| <p><b>SUNDRY NOTICES AND REPORTS ON WELLS</b><br/>(DO NOT USE THIS FORM FOR PROPOSALS TO DRILL OR TO DEEPEN OR PLUG BACK TO A DIFFERENT RESERVOIR. USE "APPLICATION FOR PERMIT" (FORM C-101) FOR SUCH PROPOSALS.)</p>      |  |

Goodnight Midstream Permian, LLC would like to revise their SWD casing and tubing construction in the following manner:

## Proposed Wellbore Schematic – Attachment III-1

VERLANDER SWD #1 – API# 30-025-50632  
2482' FNL & 1277' FEL, Unit H of Sec 12-T21S-R36E  
Lea County, New Mexico

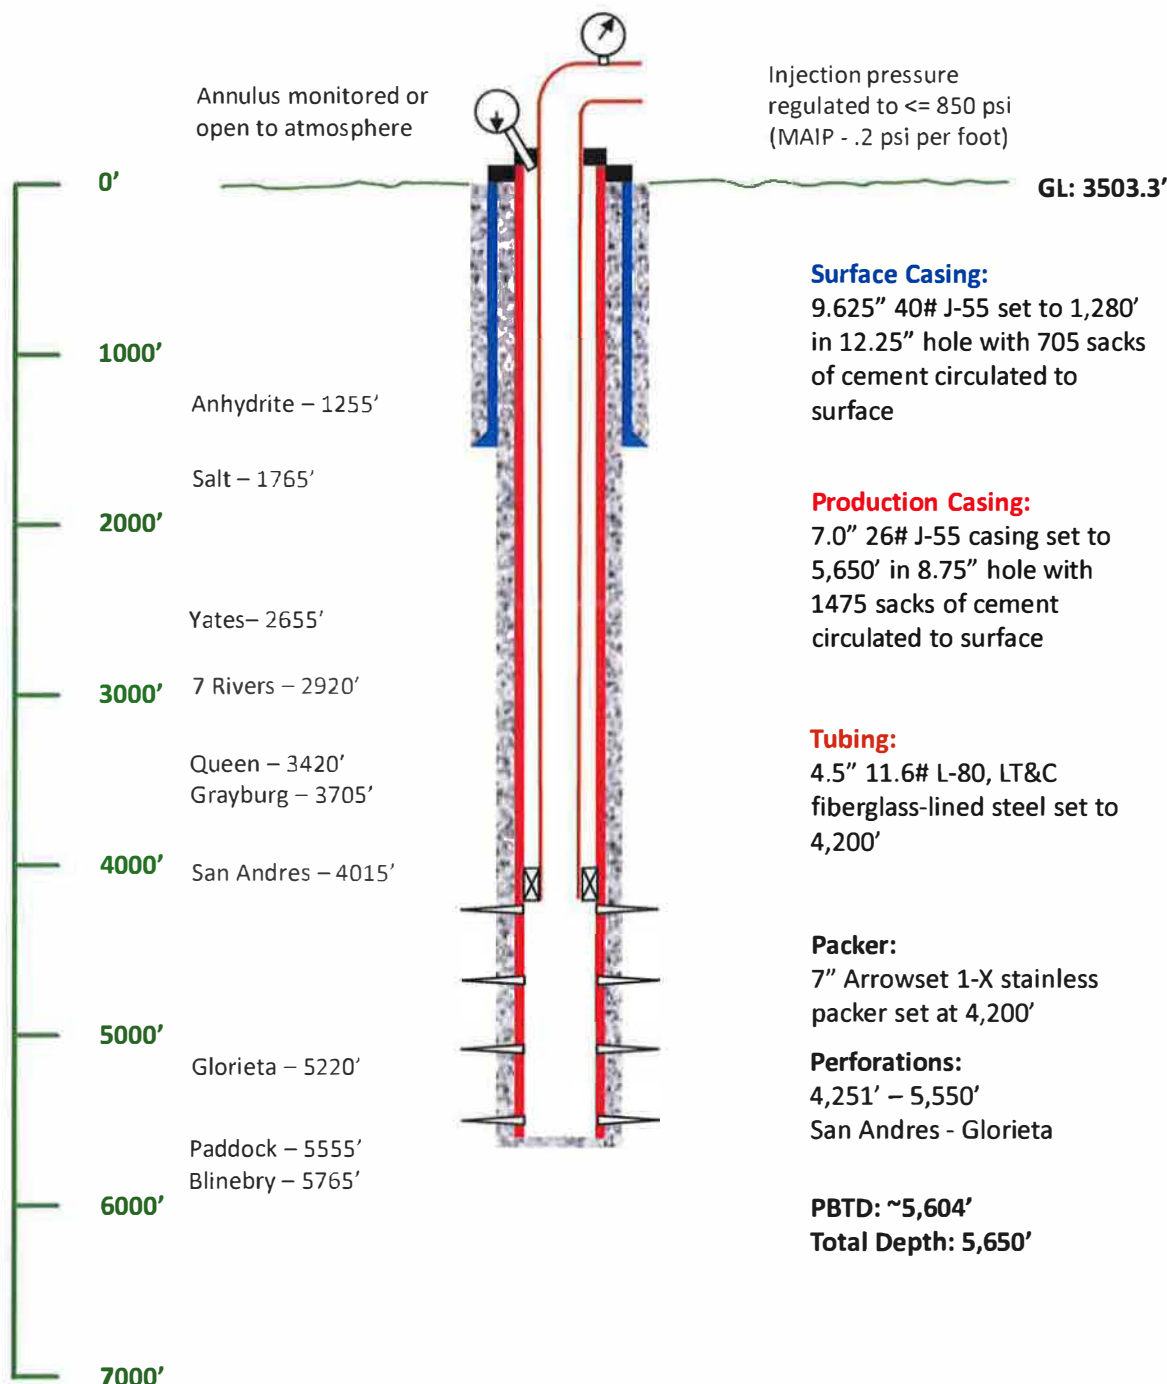
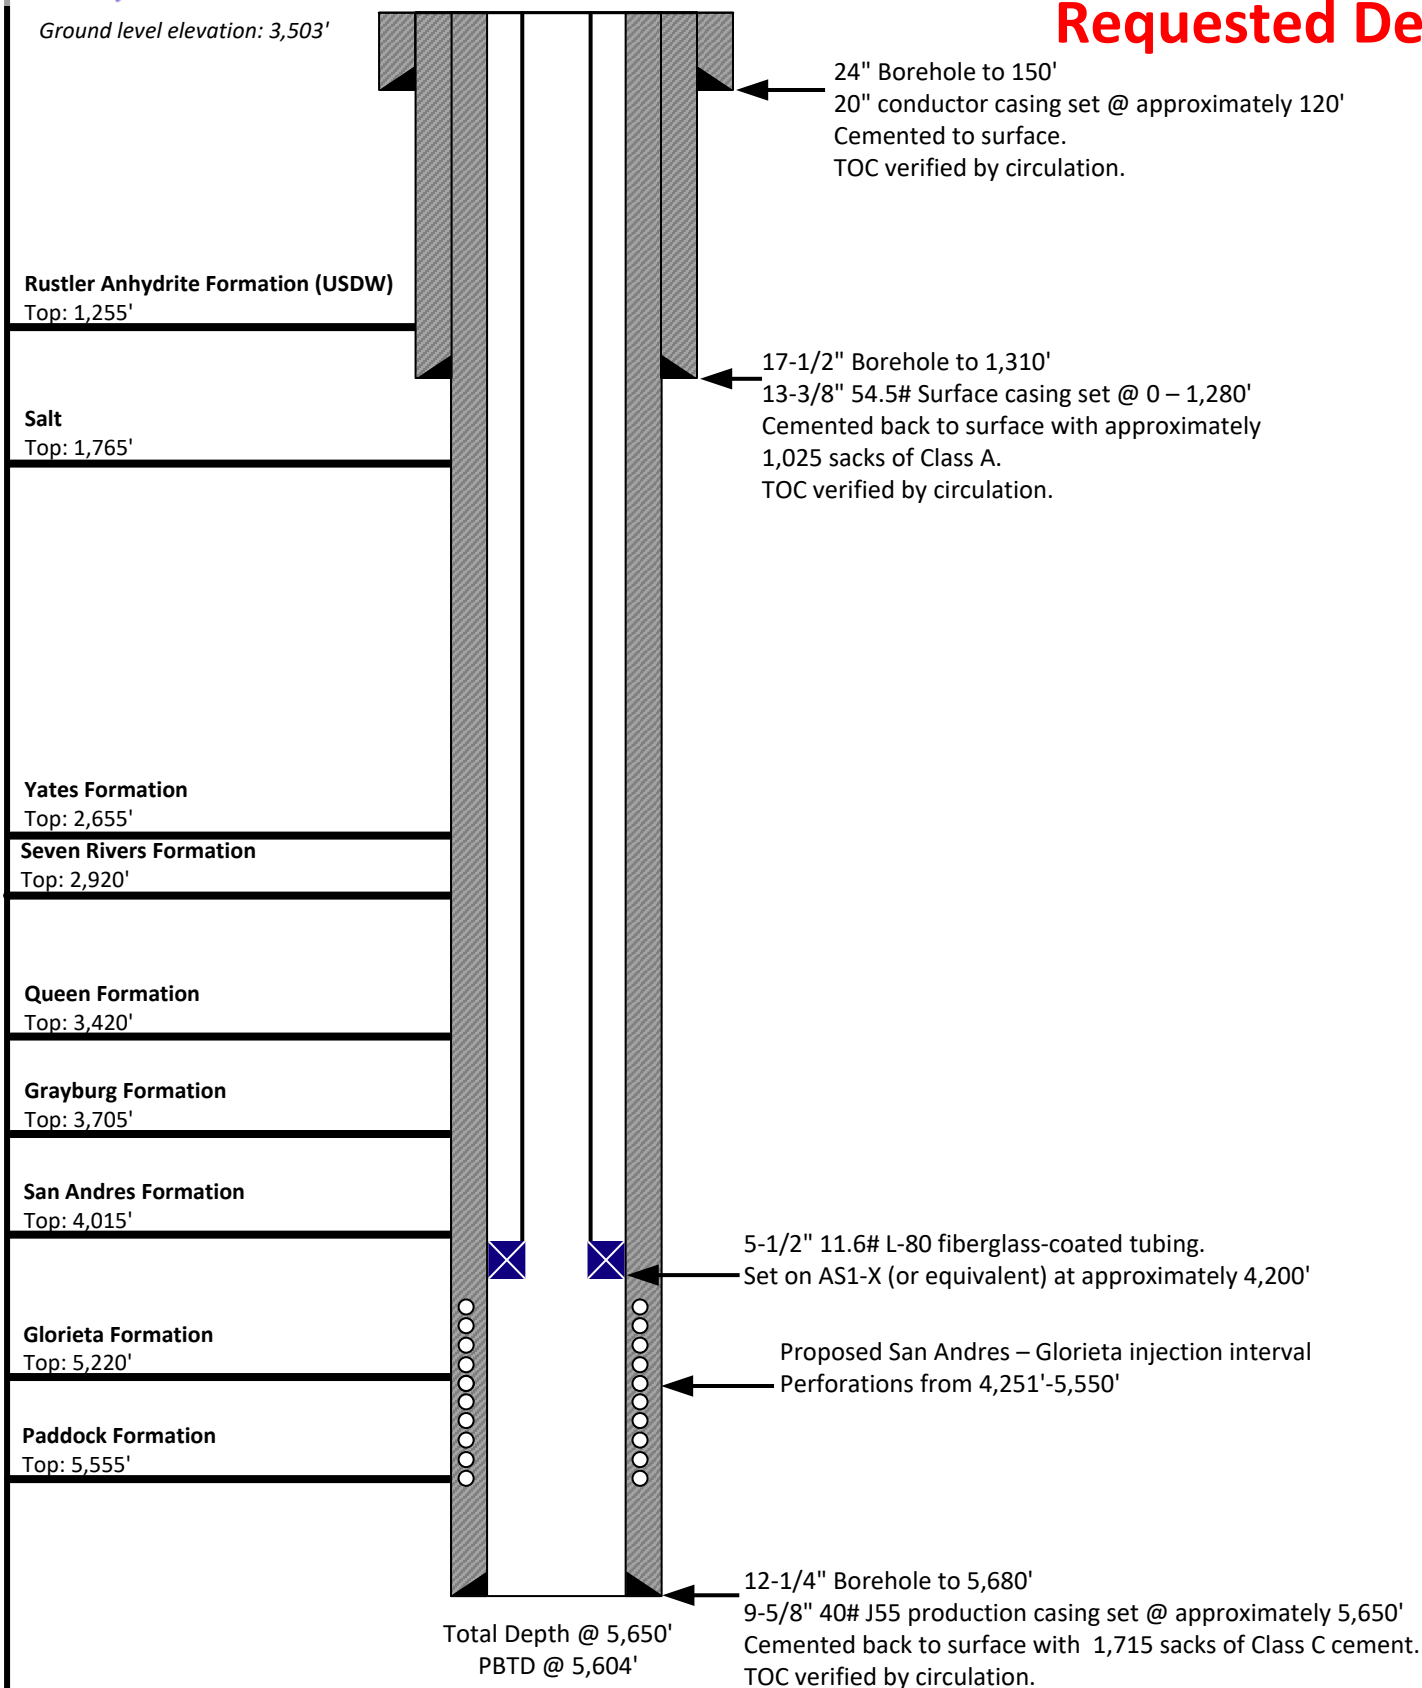
| Casing            | Current Design | Requested Design |
| Surface Casing    | 9.625"         | 13.375"          |
| Production Casing | 7"             | 9.625"           |
| Tubing            | 4.5"           | 5.5"             |

Attached to this filing is the current approved WBD and a WBD reflecting the requested changes.
